**Circular 232/2020**

**Subject:** Safety Bulletin on GEPA freefall release system

## **GEPA Modification (LSA Code IV,4.7.6) for Release Mechanism of Free Fall Lifeboats on Existing Vessels**

## **NO:19/001.rev1 FREEFALL LIFEBOAT RELEASE SYSTEM MODIFICATION** *(total 2 pages)*

**MODIFICATION PLAN**

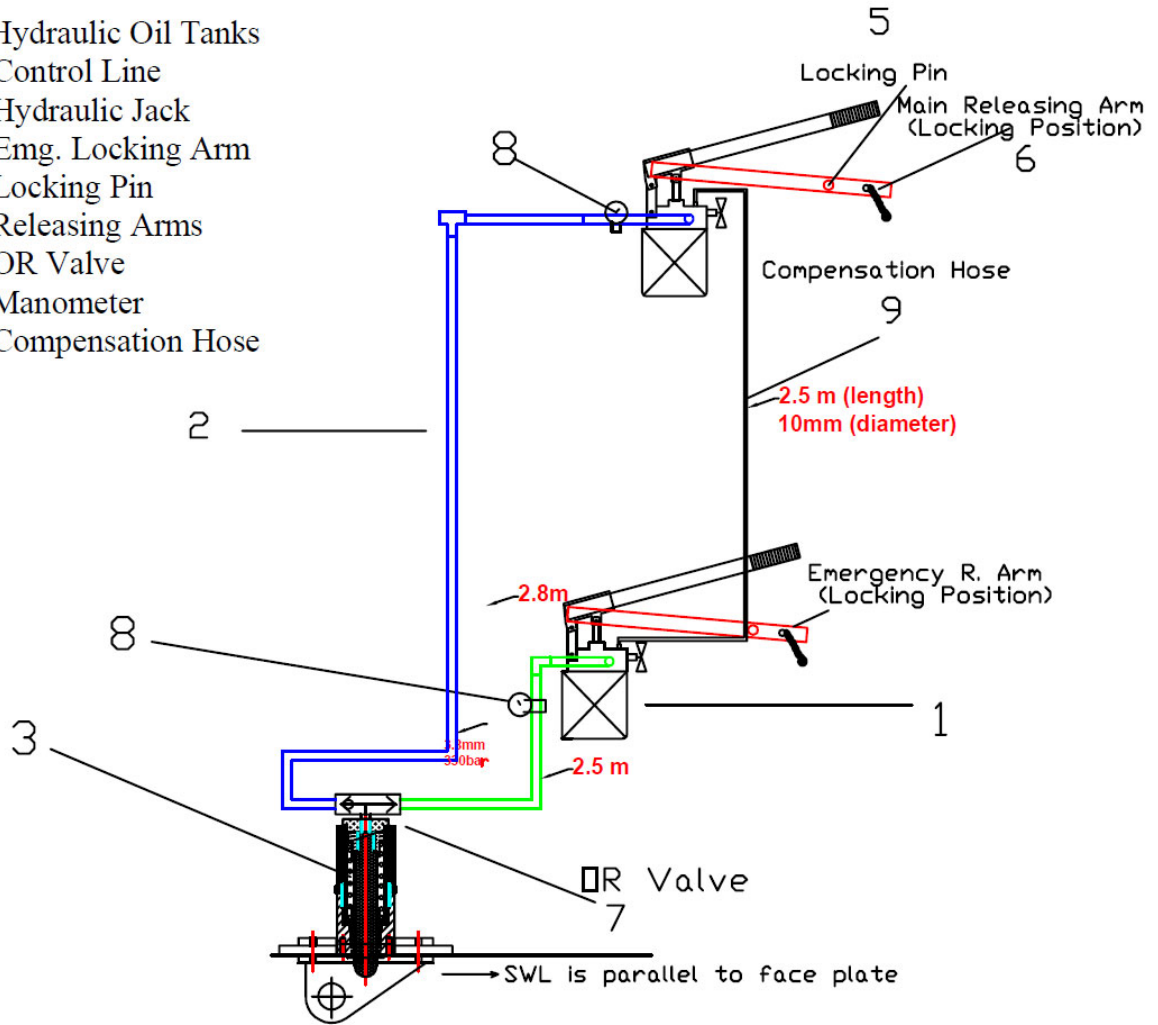
- 1-Hydraulic Oil Tanks
- 2-Control Line
- 3-Hydraulic Jack
- 4-Emg. Locking Arm
- 5-Locking Pin
- 6-Releasing Arms
- 7-OR Valve
- 8-Manometer
- 9-Compensation Hose

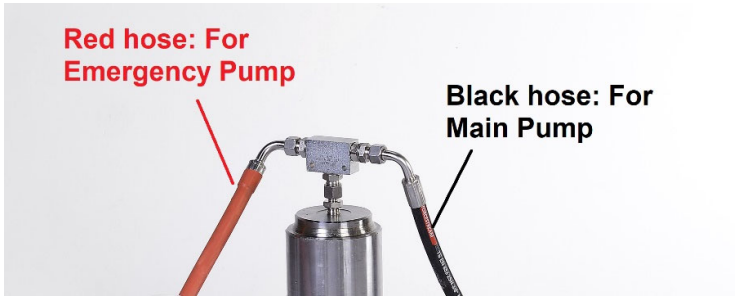
1. Hoses are to be removed from main/emergency pump.

2. Hose which is connected to hydraulic jack is also to be removed

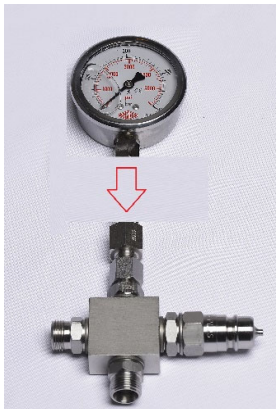
3. OR valve is to be fixed to hydraulic jack

4. Black color flexible hose is to be attached to OR valve input (left side) and red color flexible hose is to be attached to OR valve input (right side)

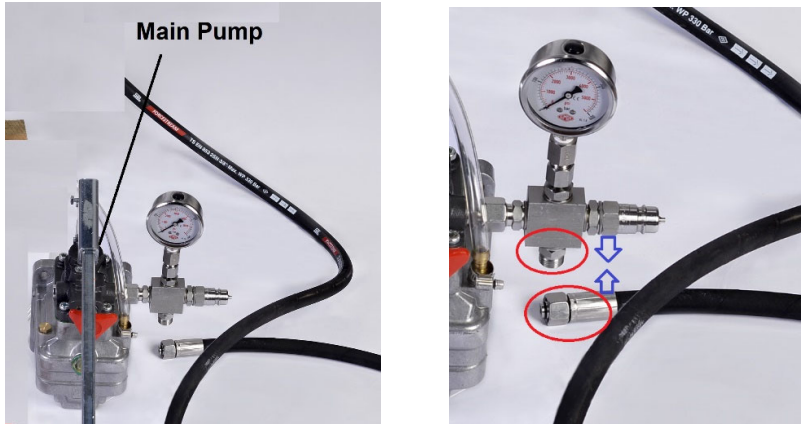
5. Manometers will be placed on 4 way hydraulic adaptor on Main/Emergency pumps

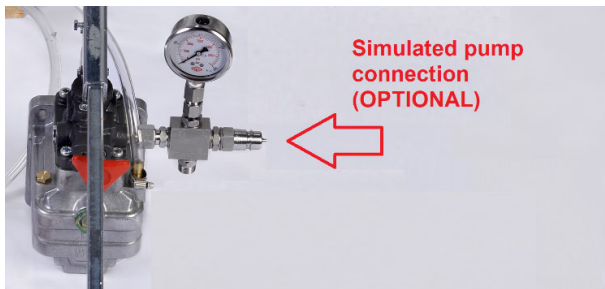
6. Black color hose is to be connected to Main pump inlet

7. Red color hose is to be connected to Emergency pump inlet

8. All required connection fittings must be fixed tightly and in correct order. Do not forget to use the gaskets for each connections.

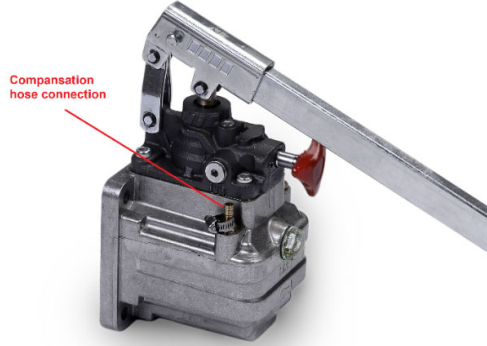
9. Simulated Pump can be connected by Quick Jack (Optional during test time)

10. Compensation hose (PVC Plastic) will be connected to oil tanks between Main/Emergency Pumps.
